***A.T. Still University  
Expansion***

**Planning & Zoning Submittal  
City of Mesa  
PS15-089**

**November 30, 2015  
Revised: February 29, 2016**

**Responses to Planning Staff Design Review Comments**

PBE.1

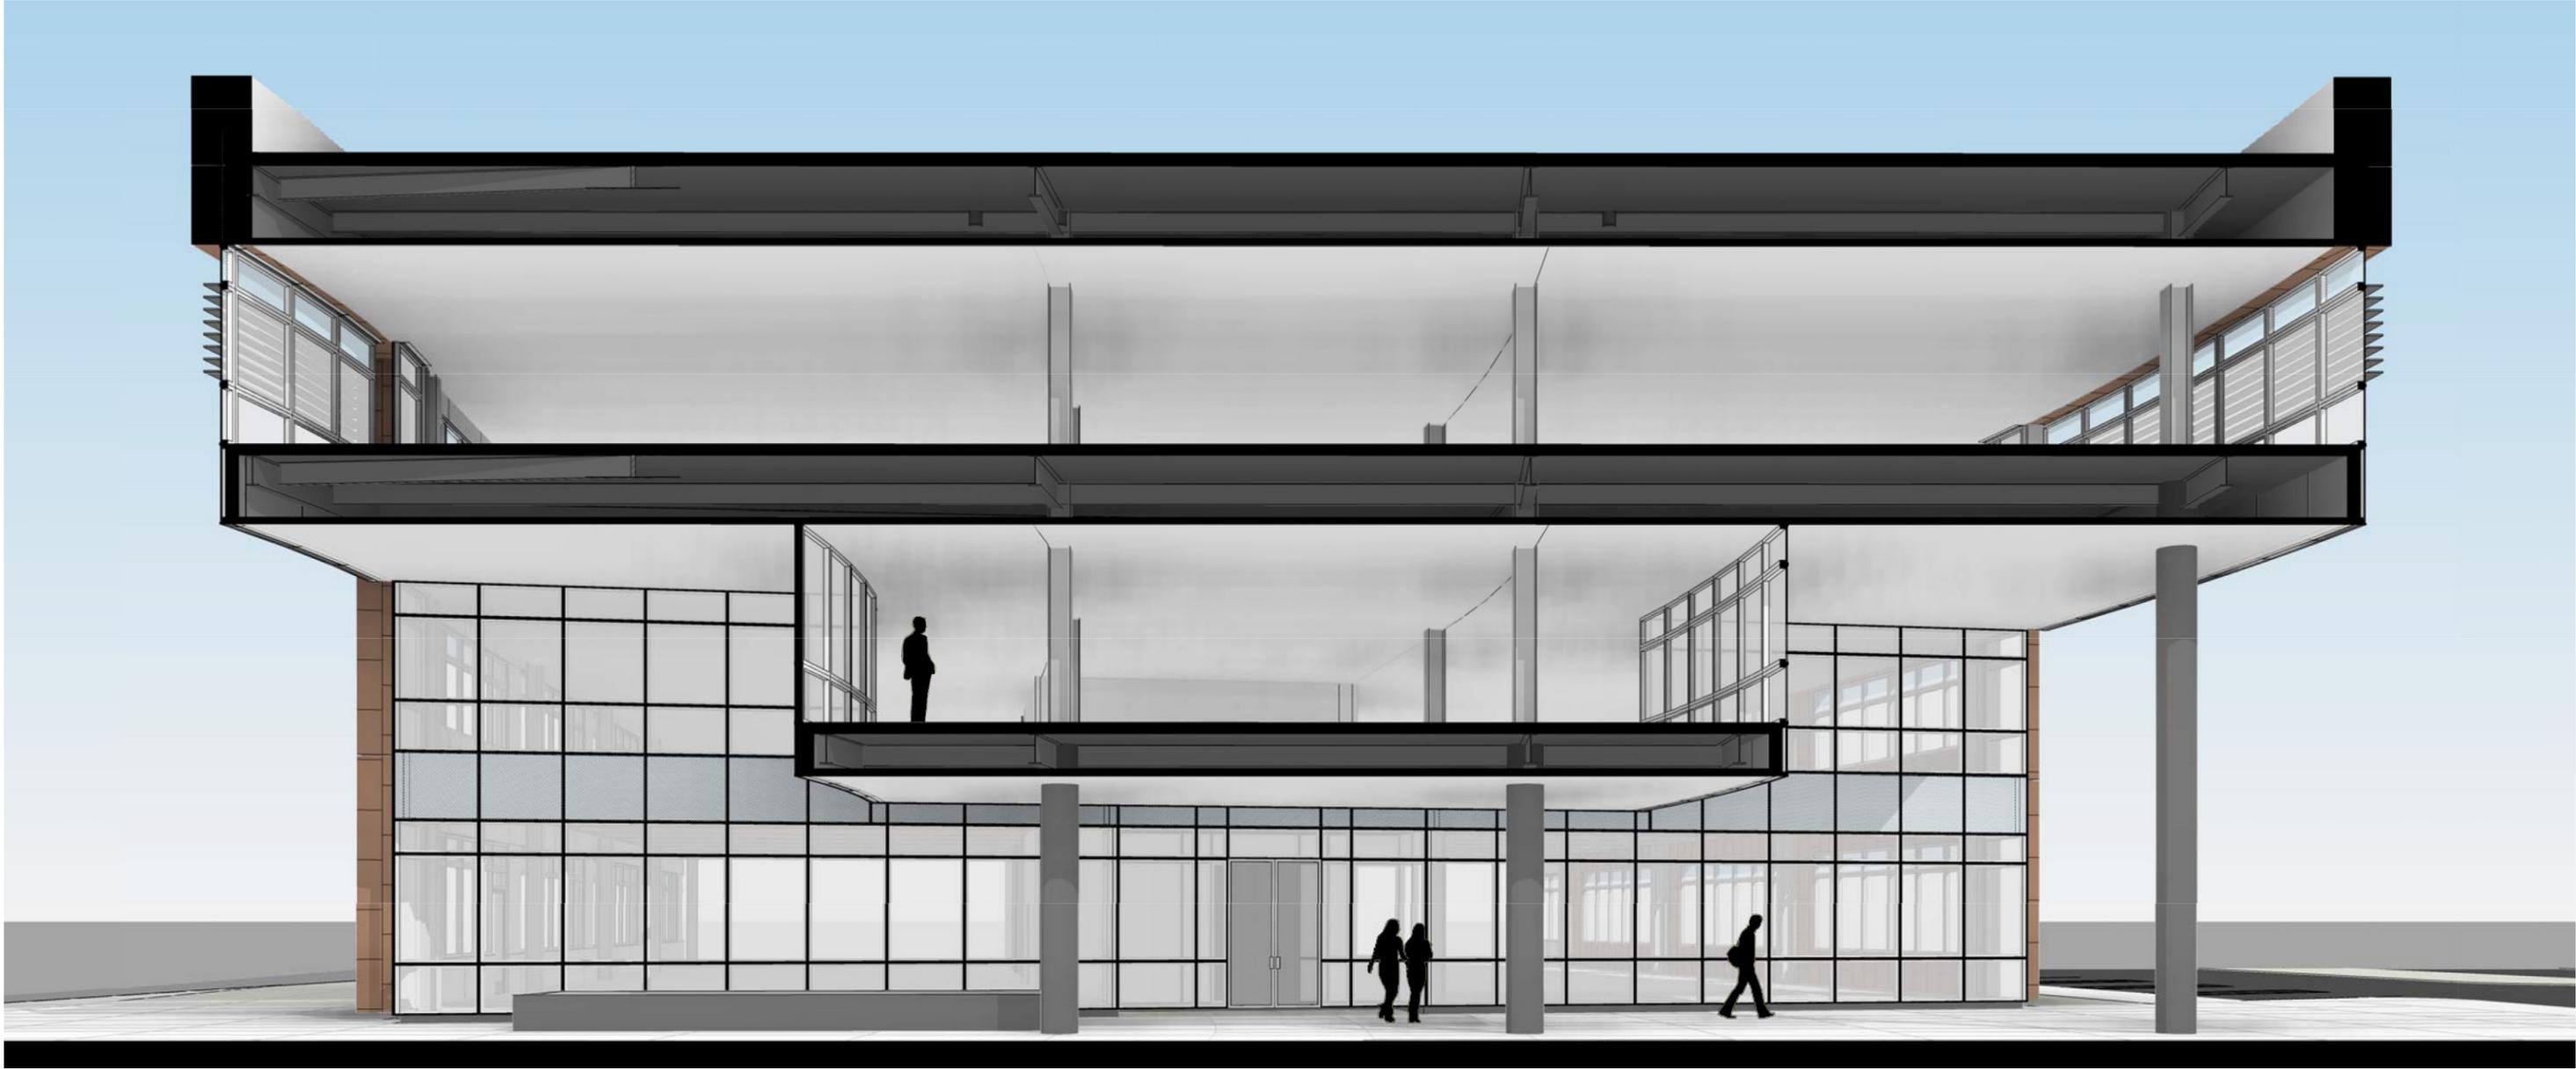
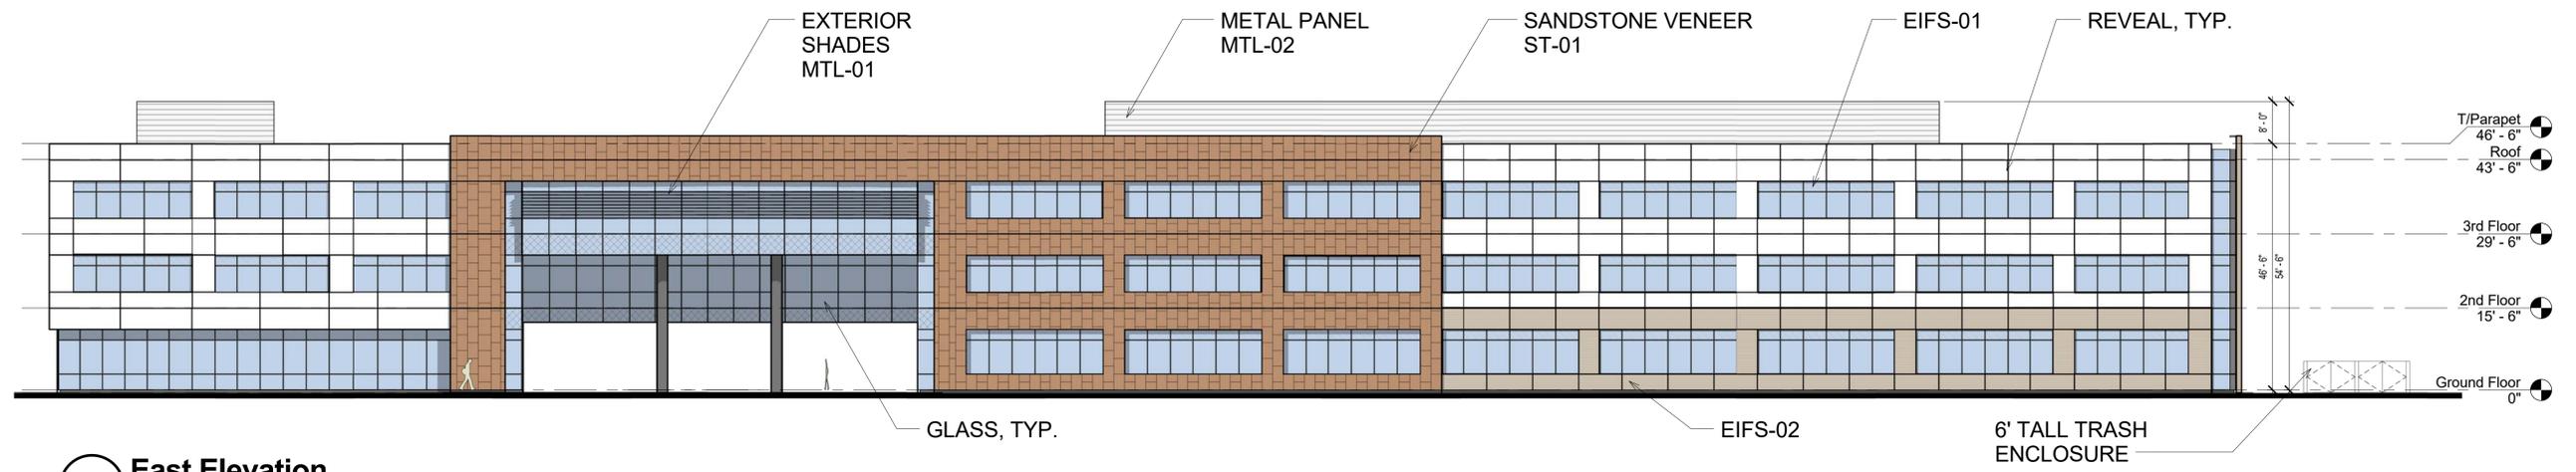
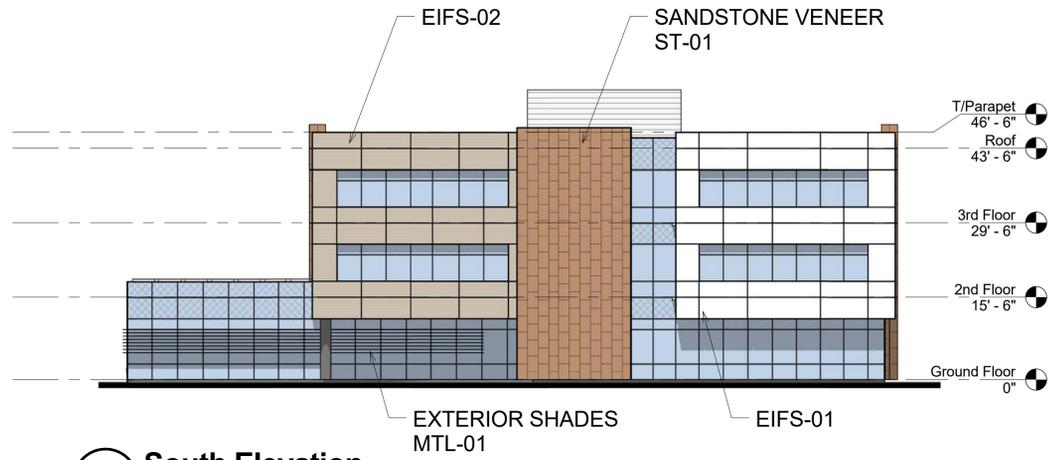
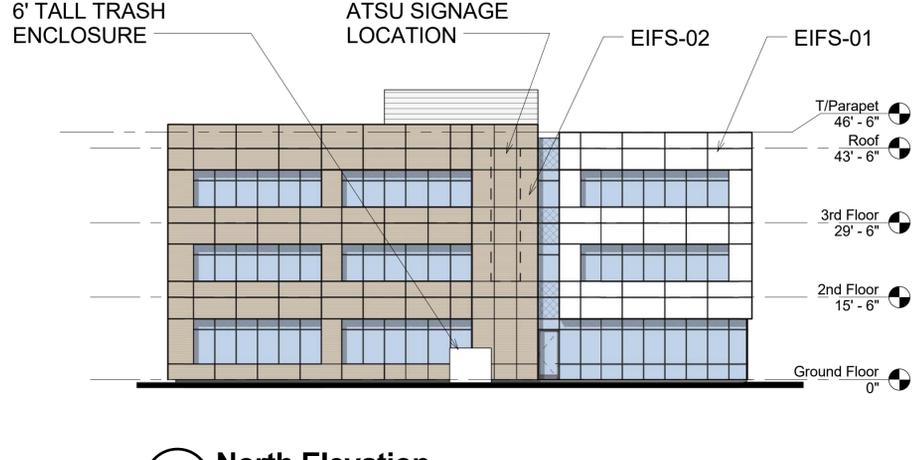
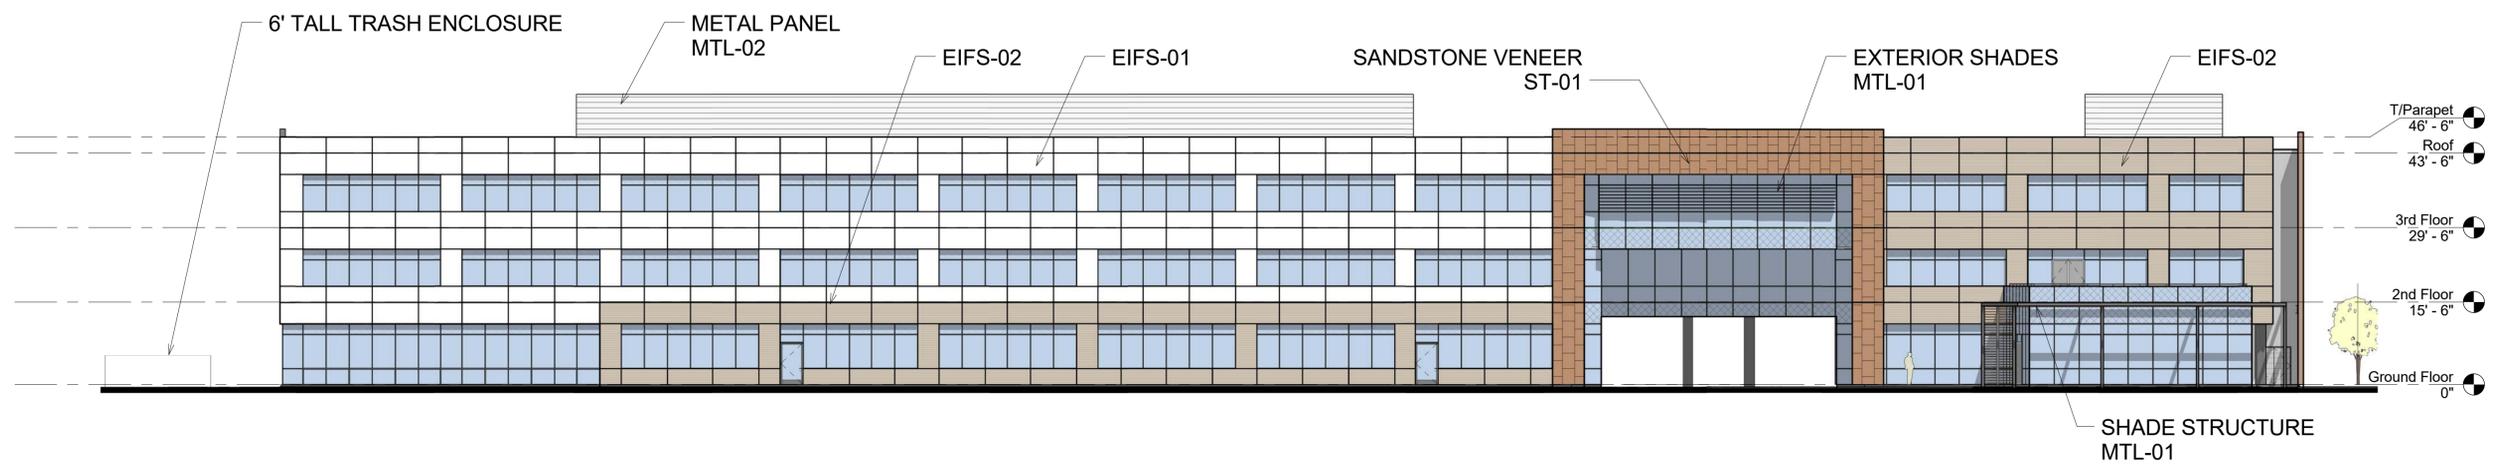
- i. The elevations make the building appear flat, however the renderings shown earlier in the process indicates use of scoring and reveals and recesses, these will need to be shown and understood because texture and plane changes are an expectation of Design Review.

- **Response: Elevations have been modified to show shadows and better depict material and plane changes.**
- ii. Color changes are generally not supported except there where this a change of plane or in material; the elevation for the west side of the academic building shows a change in color on the first floor but no change in material nor color (EIFS-02 to -01); the ground level EIFS-02 on the east elevation switches to all three floors on the north elevation, these is not supported without some other element to break up these elements.

- **Response: EIFS walls are articulated by plane changes and/or reveals at color changes.**
- iii. North elevation needs additional design details since it will be prominent architectural site for those parking in the north parking lot and from the Superstition Freeway.

- **Response: North Elevation has been modified. See attached elevations.**
- iv. What is the shadow line shown above the windows on the first floor that is continuous along the west elevation (at north end) but only above windows on second and third floor?

**A** ATSU Garage Concept Option 1

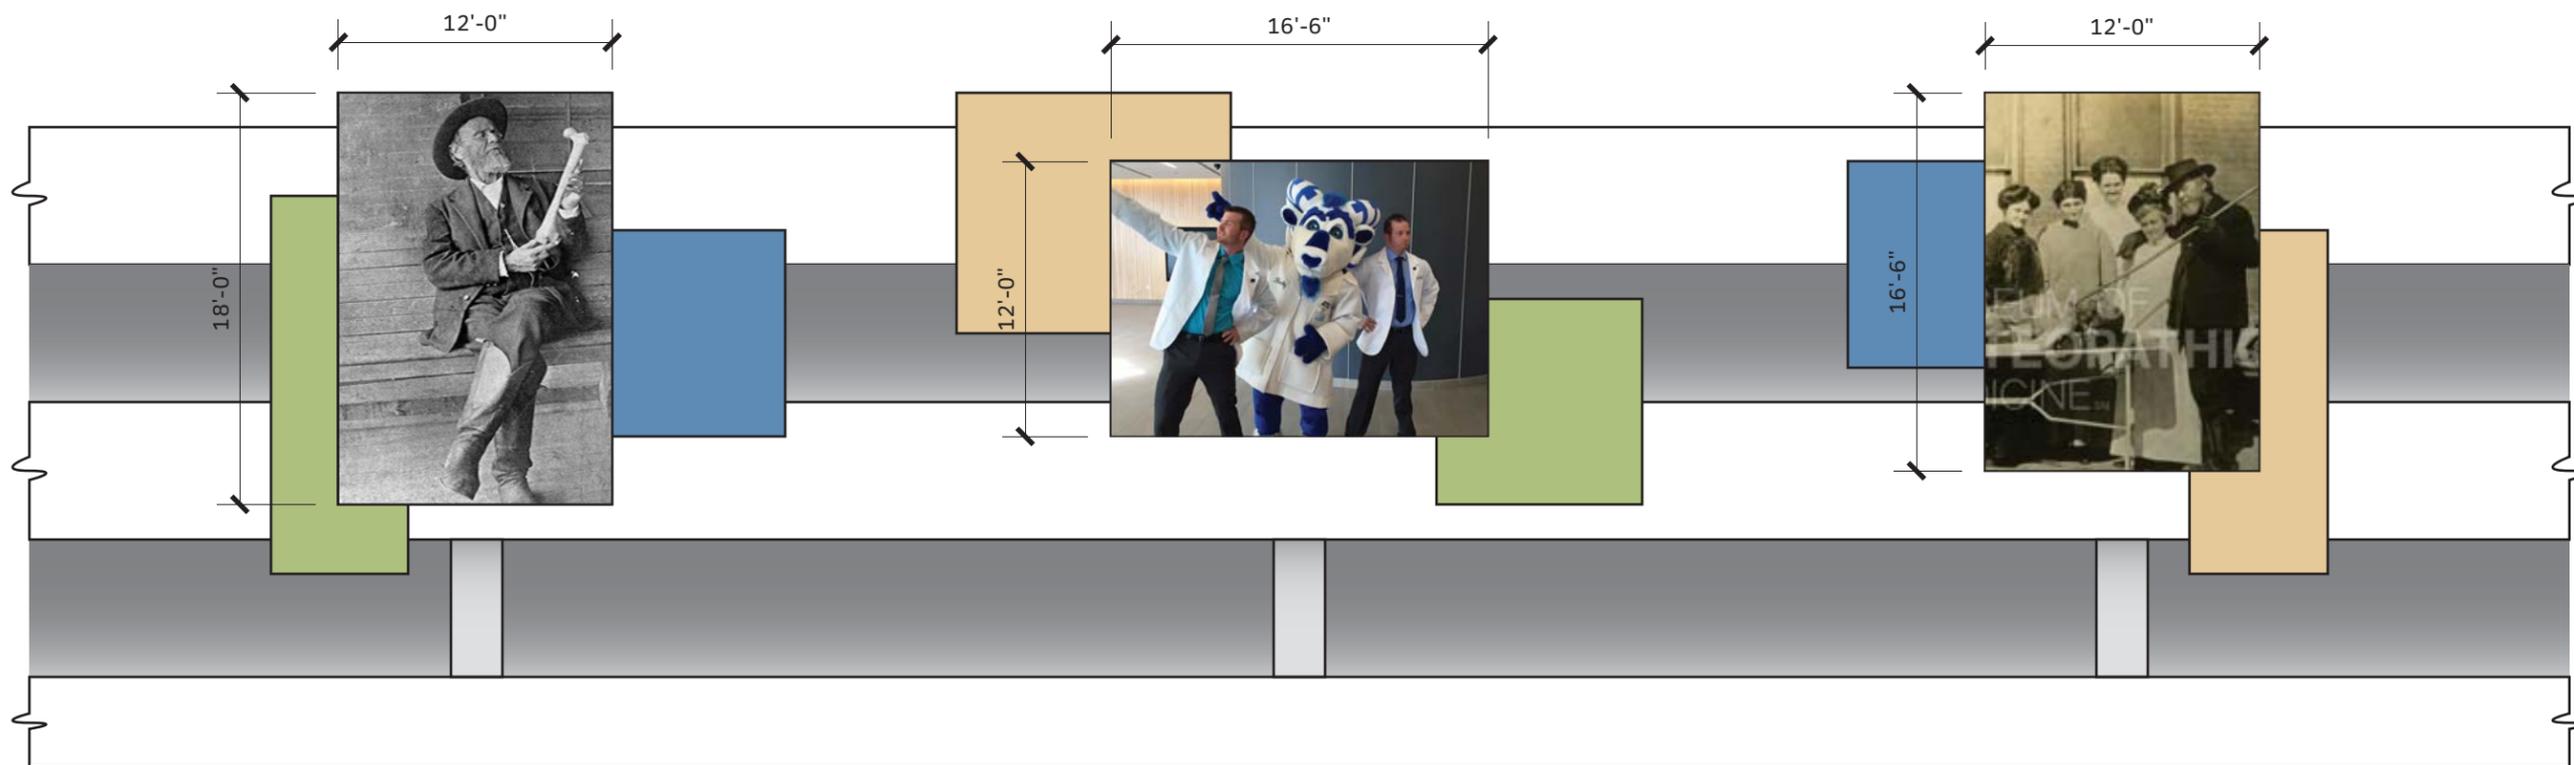
- i. Will a bolder color be considered for the precast concrete on the elevation?
  - **Response: Bolder colors may be considered however the current palette anticipates more neutral background to the perforated metal screens, sandstone elements and brand identity graphics.**

- ii. As proposed in the P&Z Board site plan review, staff proposes use of an open barrier system for the ground level of the garage using perforated metal, ironwork or similar devices. The solid barrier wall is not needed on the east elevation since the existing Recker Road screen wall will shield headlights.

- iii. Recommend adding vertical garden elements to the east garage elevation through trellises with climbing vines, or with planter boxes with overhanging plants such as cat's claw vine, see attached photos for examples.

- **Response: Use of planter boxes will be studied further. Concerns are long term viability in desert environment.**
- iv. North side of garage needs additional design details since, such as the perforated metal panels used on the south side of the garage.

- **Response: Decorative perforated metal, as used on the south and east elevations, has been added to the north elevation.**
- v. Provide examples of what the brand identity graphics may include to help the DR Board understand.

- **Response: No solid barrier is anticipated for the east elevation at ground level as requested by this review and local law enforcement. However this may be contradictory to the expressed preference of some neighbors. We are willing to proceed as directed once priorities have been clarified**
